2022-04-20

**REQUEST FOR TENDERS
SUPPLY & INSTALLATION OF NEW HANDRAIL
RFQ 24 (2022-04)
ADDENDUM #1**

PEDESTRIAN SAFETY
BUS LAYDOWN
NEW HANDRAIL

HANDRAIL DETAIL 16FT SEGMENT @ TTC -LAYDOWN AREA- PREFAB HANDRAIL

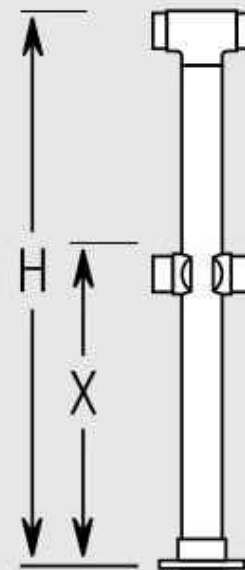
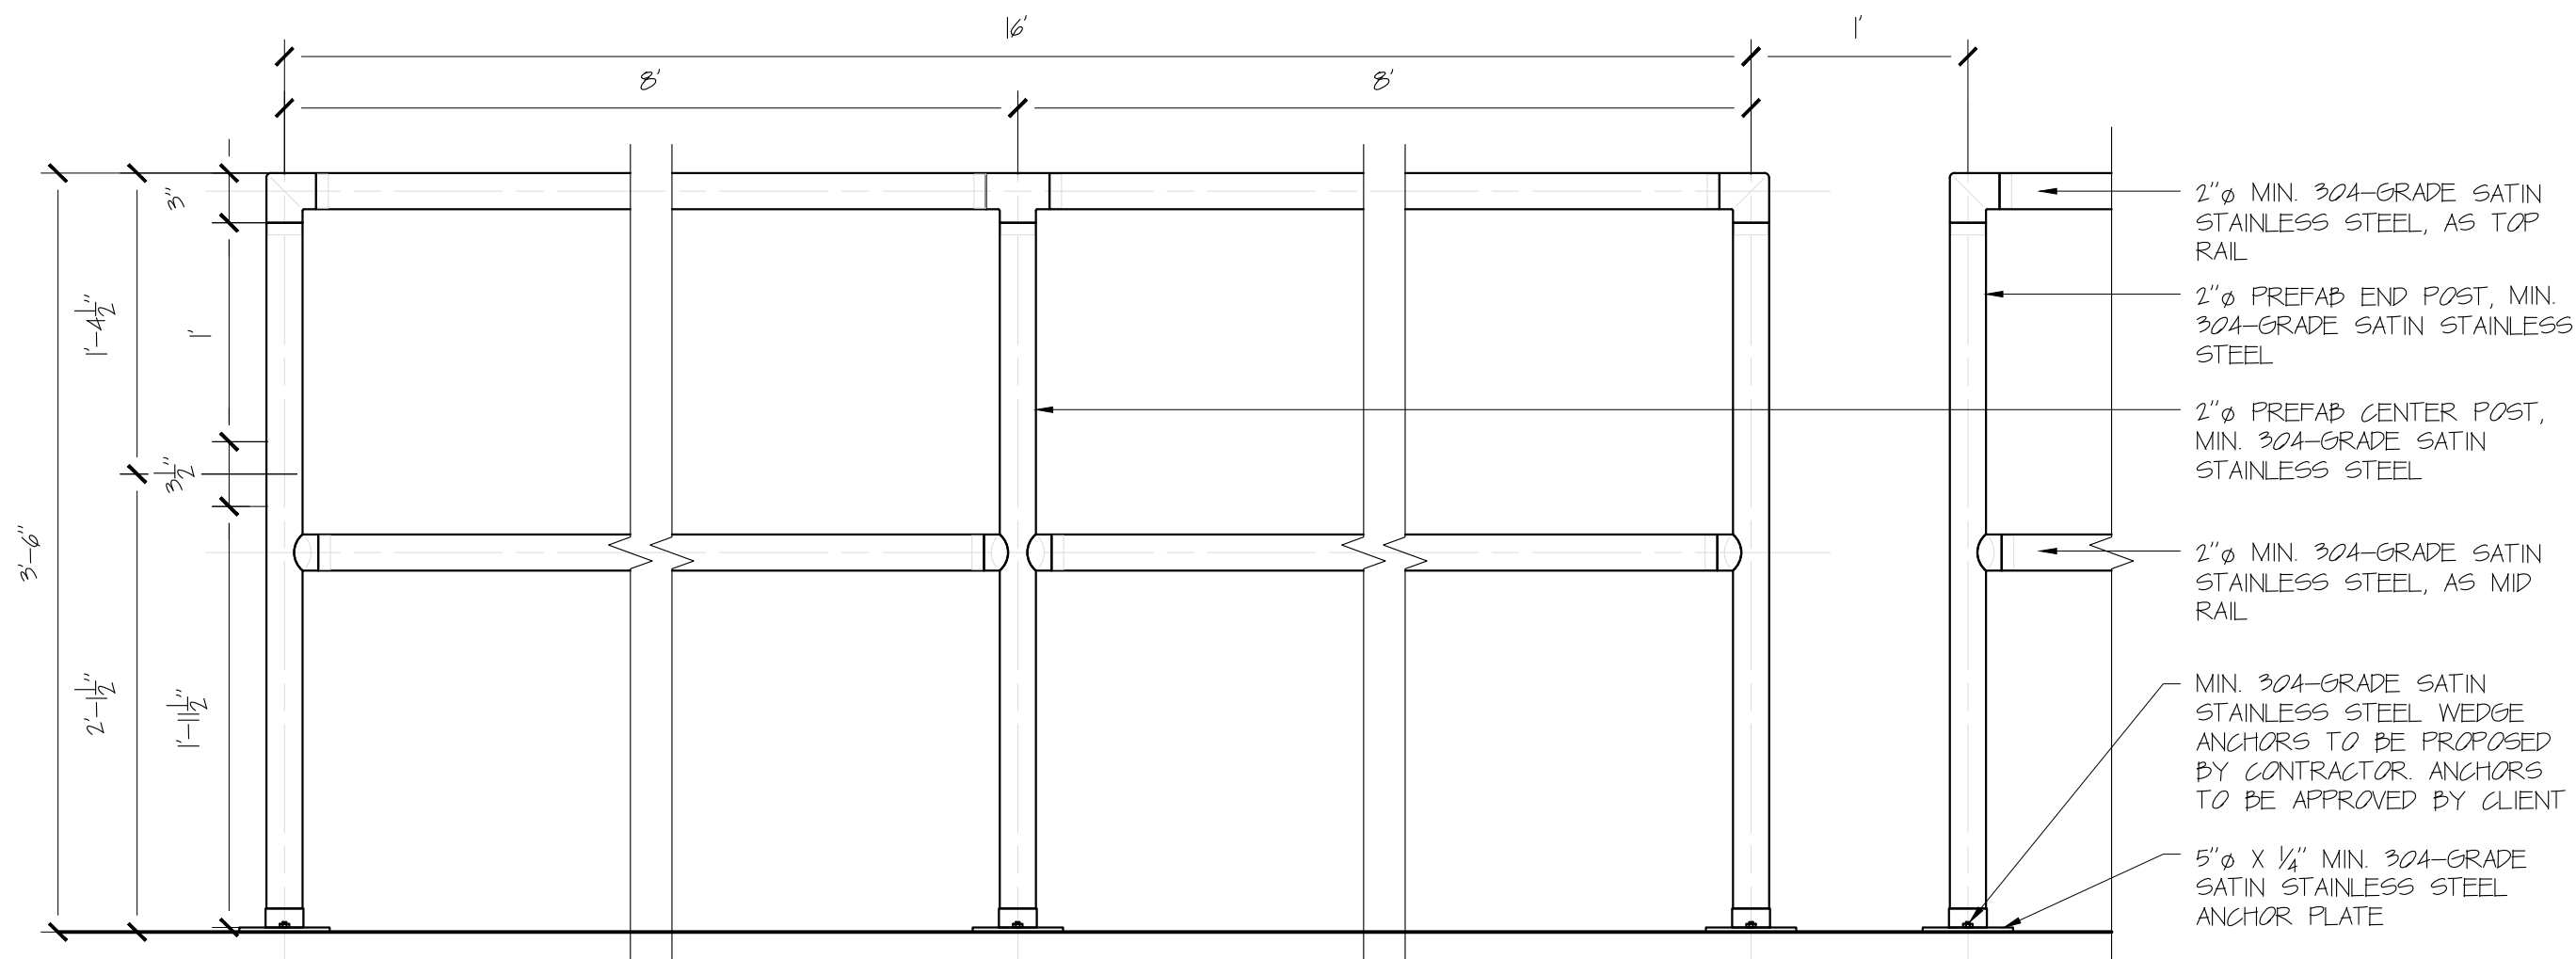
As an alternate would you accept the 20'0" sections with a radius corner (like the one in the attached picture – there would be an 3rd post in the centre of a 20'0" section)? The shop fabrication time is a little bit faster.

See revised drawings attached. Railing product has been revised.

EACH RAIL SEGMENT IS 16' LONG (SUB-SEGMENTS OF 8' EACH) WITH (2) 42" TALL END POST, (1) 42" TALL CENTER POST, ANCHORED TO (1) PLATE PER POST, (3 OR 4) ANCHORS PER PLATE, (2) 8' TOP RAIL AND (2) 8' MID RAIL. POSTS AND CONNECTORS ARE PREFAB BY MANUFACTURER. RAILS TO BE GLUED TO END/CENTER POSTS FOLLOWING MANUFACTURE'S INSTRUCTIONS.
